IEEE P802.3cs Terminology

John D'Ambrosia,
Futurewei, U.S. Subsidiary of Huawei
IEEE P802.3cs Sept 27, 2021
IEEE 802.3 September 2021 Interim

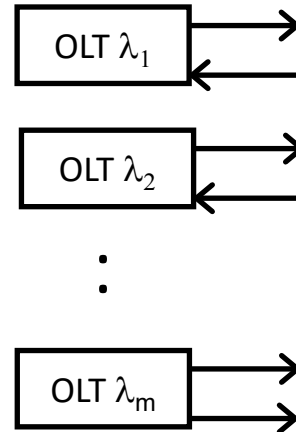
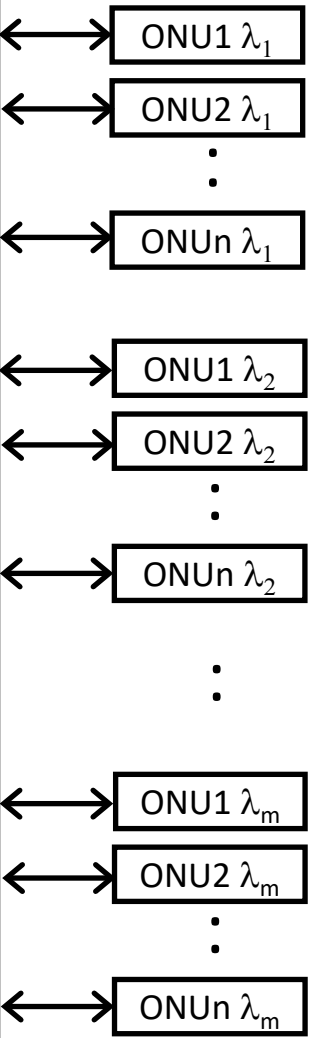
It is not clear if this is what is meant by “Black Link” from Fig 164-2.

The black link approach can be used to develop the specification of the input, output, and transfer characteristics for each unique unidirectional transmission path.

Following 802.3ct example – Super-PON Black Link?

What is the name the TF wants ?

Figure 164-3—Super-PON PMD Test Points

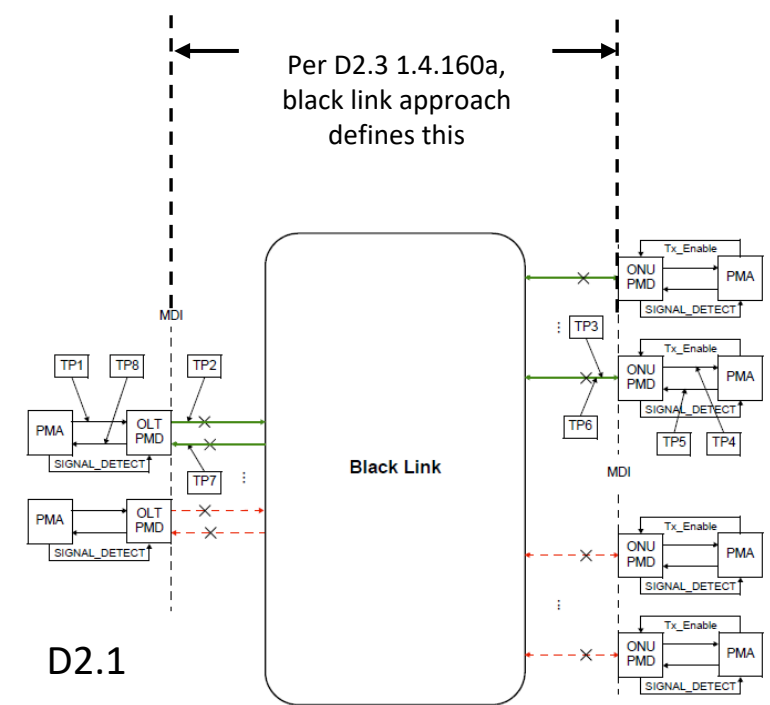
Where is the “Black Link”?

- Per response to comment #250 from 9/10/21
 - Fig 164-3 from D2.1 was agreed to be used per proposed response. See
 - Rename "164.2.8 Black link specification" to "164.2.8 Super-PON optical path specification"

- Fig 164.2 implies that the “PON medium” is noted as consisting of Fiber Pair + black link + Fiber Pair
 - What is the “black link approach” defining?
 - Fiber + black link + fiber?

- MDI to MDI (Super-PON medium)?
 - Super-PON optical path?

Figure 164A-1—Example of Black link implementation

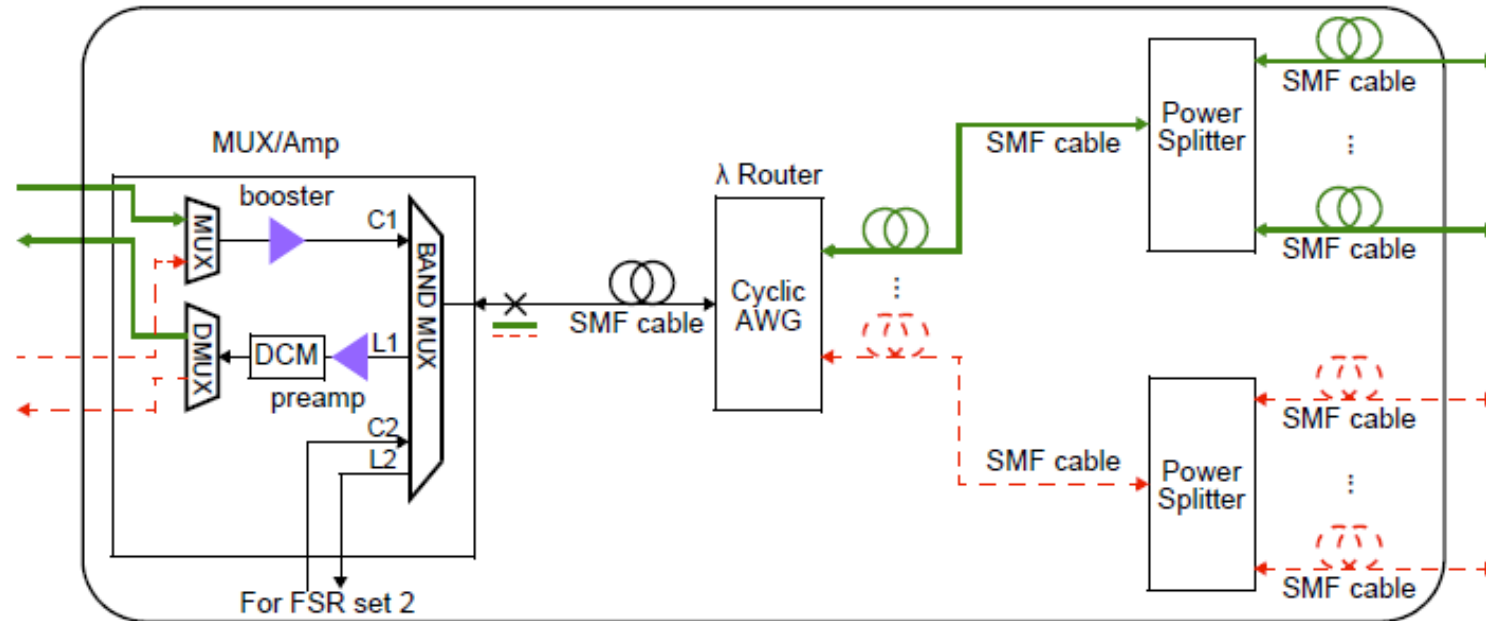
SMF cabling is noted on one side, but not the other of the Super-PON black link implementation
